# Access Compliance Report

## Public Rights-of-Way

### (Curb Ramps)

| Intersection ID: 25006 | Main Street: BENRIDGE_LN | Cross Street: TRUSCOTT_RD | Location: S            |

| ADA ID: 636BF0CCF7B8   | Ramp Type: PerpDiag      | Initial Pass/Fail: Fail   | Overall Compliance: No |

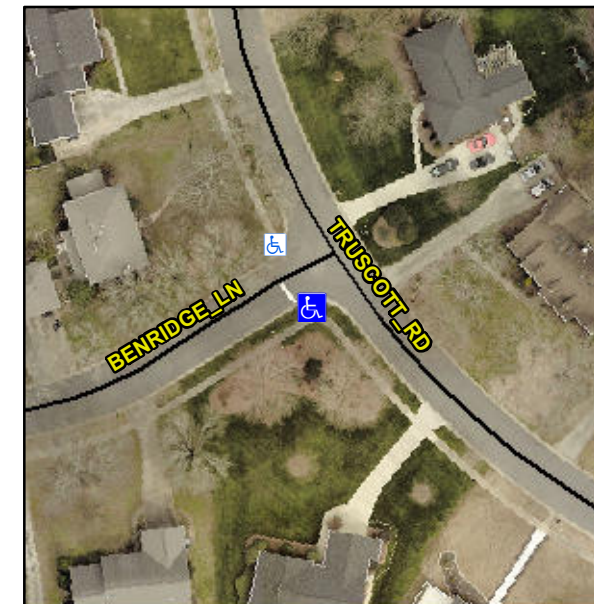
**Not Found, R304.5.3**

| Compliance | Description           | Data | Compliance | Description                 | Data |
|------------|-----------------------|------|------------|-----------------------------|------|
| N/A        | Ramp Length (in)      | 80.5 | Yes        | Ramp Slope (%)              | 7.4  |
| Yes        | Ramp Width (in)       | 69.0 | No         | Ramp XSlope (%)             | 7.3  |

**Remove & Replace Curb Ramp With Two New Directional Ramps or Equivalent.**
